**BLOOMINGTON HISTORIC PRESERVATION COMMISSION**

**Thursday March 8, 2012**

**AMENDED AGENDA**

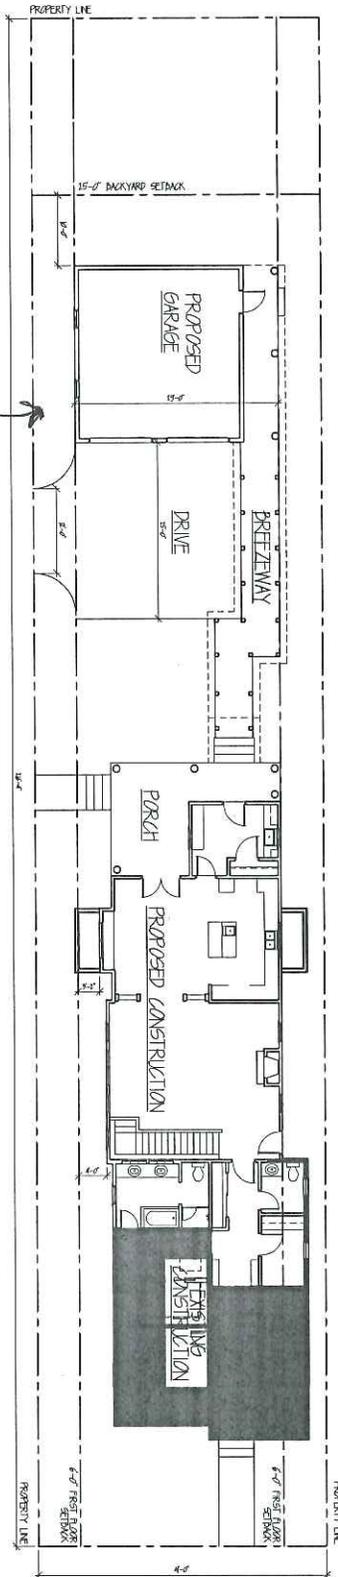
The design subcommittee expressed concern about the dimensions of the columns (round) to be used and it was mentioned that several rehabilitations in the nearby area had erred in the choice of small radius supports. Staff will support columns of at least 6-8 inches.

A metal standing seam roof is proposed. Although this material is not common in Prospect Hill houses, they are certainly more common on the accessory and rural outbuildings remain standing in the neighborhood. The roof slope is intended to mirror the slope of the house.

The drawings imply that attention will be paid to detail of trim: corner boards, band boards and drip caps, and this is included in the application request.

1) whether the redwood trim was still in their plans, as detailed on the design. The petitioners were assured that if they choose to use cement board, as with the siding, we would be satisfied.

2) whether a metal roof is consistent within the neighborhood, the period, and so on. There are examples (new and old) in PH of a few metal roofs, but they are hardly the norm. Nevertheless, it is a reasonable contemporary material and will be long-lasting.

Staff recommends approval with the understanding that the columns be proportional to the project and that the owner seek a staff level approval for the temporary buildings on the site when they decide to remove them.

NORTH ELEVATION 9TH STREET

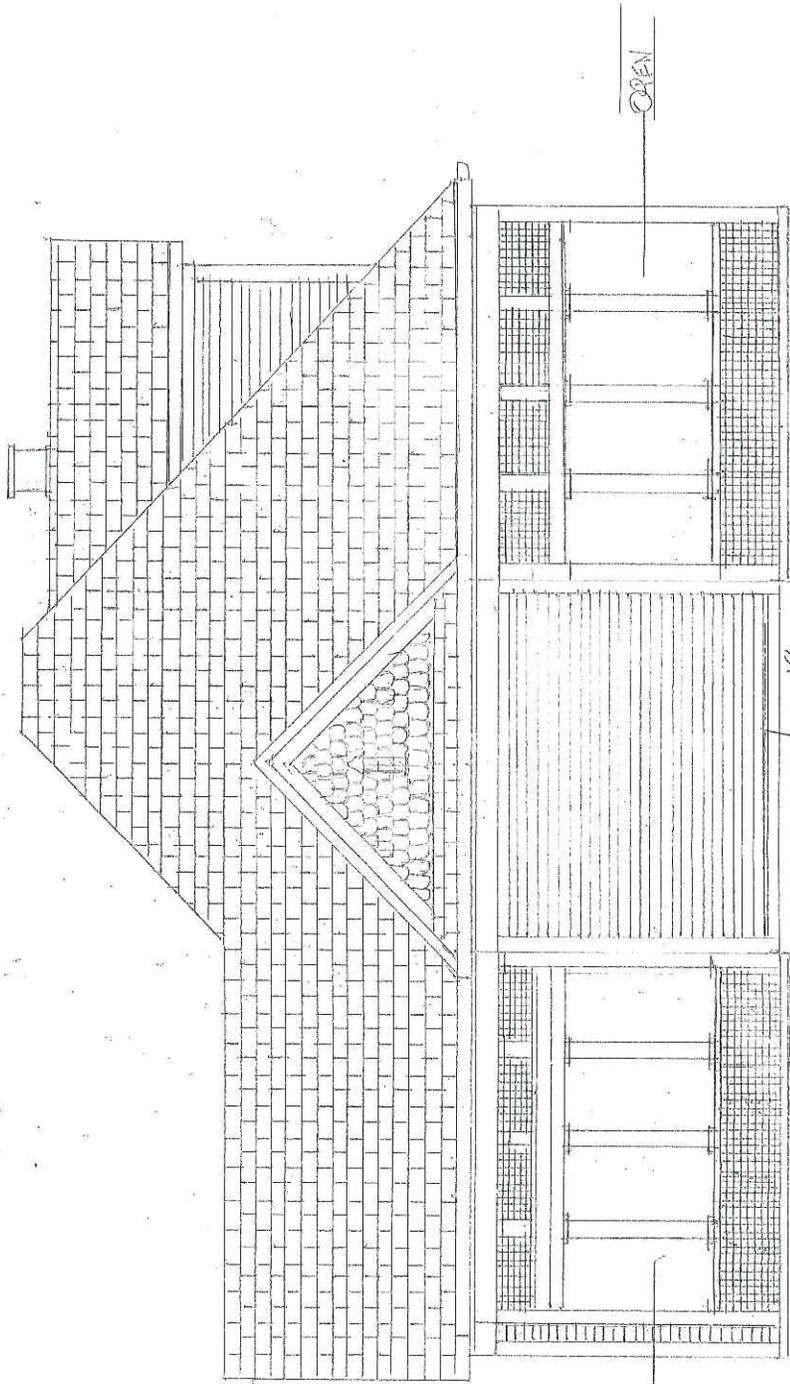
9<sup>th</sup> Street

- The two small windows that were to frame a fireplace are removed from the plans and a single window of identical proportions to the originals will be placed there.
- The paired window in the bay will be reduced to a single plain double hung.

WEST ELEVATION (SIDE NEIGHBOR)

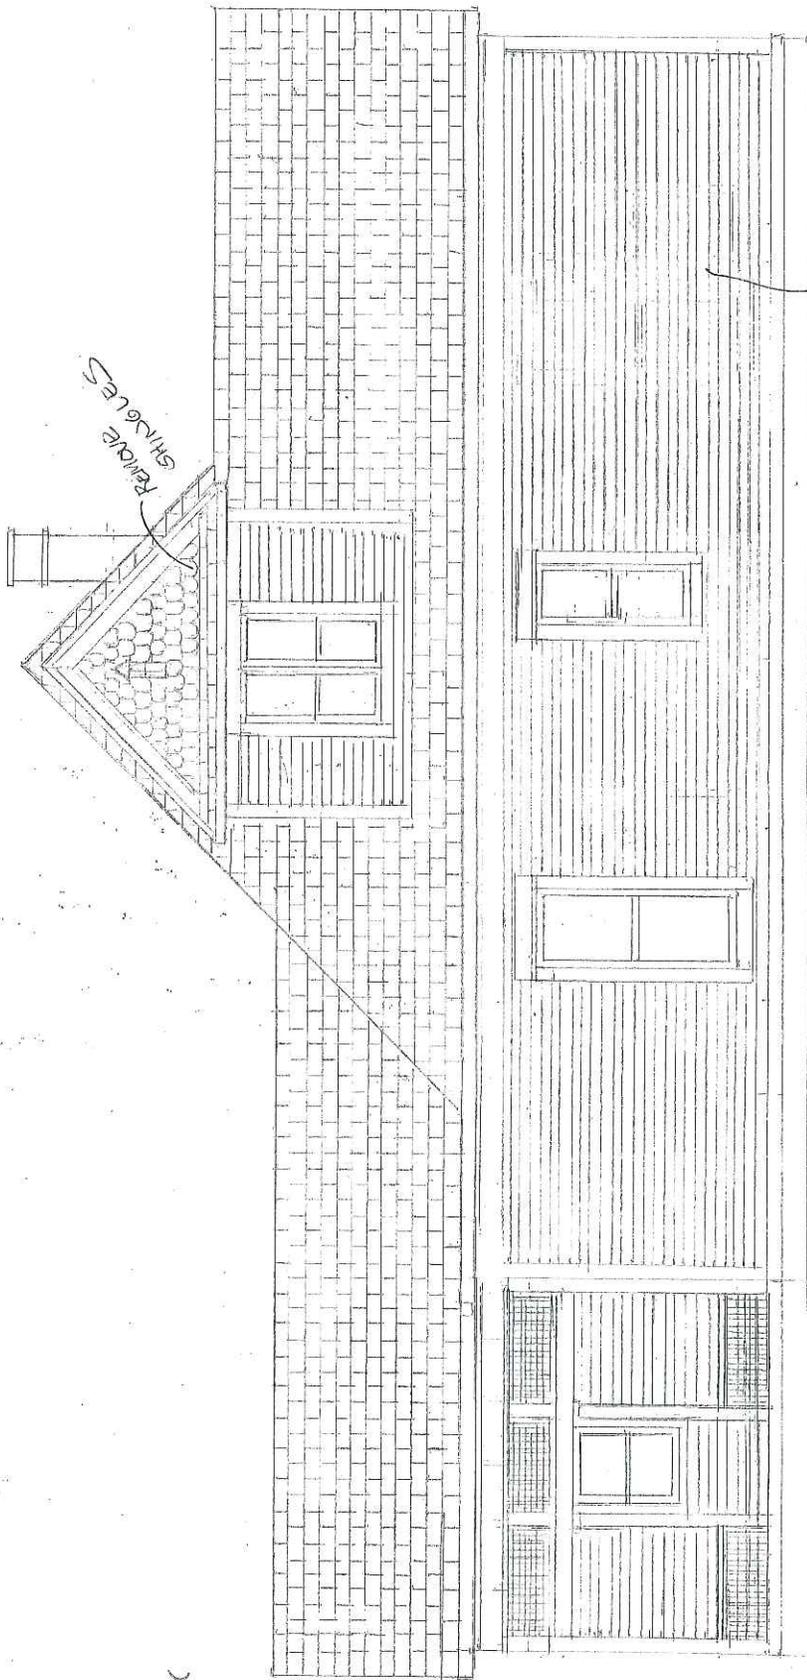
West Elevation (Neighbor Side)

- No change
